MUNCIE POWER PRODUCTS

Product Bulletin PB00078

Subject: PF4 Pump Changes

Date: October 21, 2019

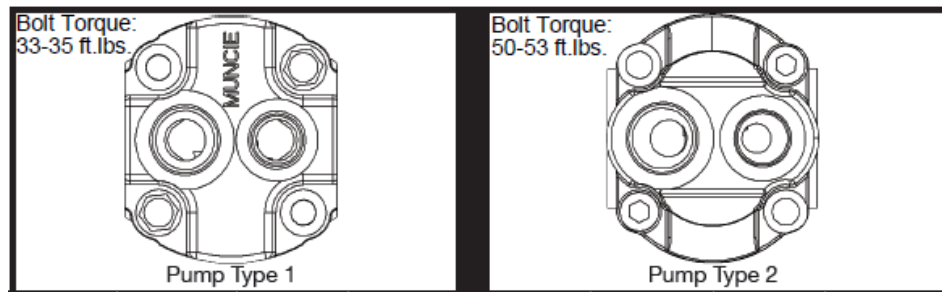
The capscrew spot face on the PF4 pump rear cover has changed and is slightly smaller and subsequently requires a smaller OD washer. The new washer part number is: 21T64303.

At the same time we have changed to a socket head vs. hex head capscrew. The socket head capscrews are a higher grade material. For the Type 2 pumps, the new capscrew torque is 50-53 ft.lbs. (68-72 Nm).

The new capscrews are black in color and have a new part number: 19T38***SH. These range in lengths of 4.00" to 6.25". i.e. 19T38550SH (5.50 in.). The new capscrew socket heads require an 8mm or 5/16" allen drive.

The new capscrews and washers will be used on both Type 1 and Type 2 PF4 pumps. The torque for the Type 1 pumps will remain the same at the lower 33-35 ft.lbs.
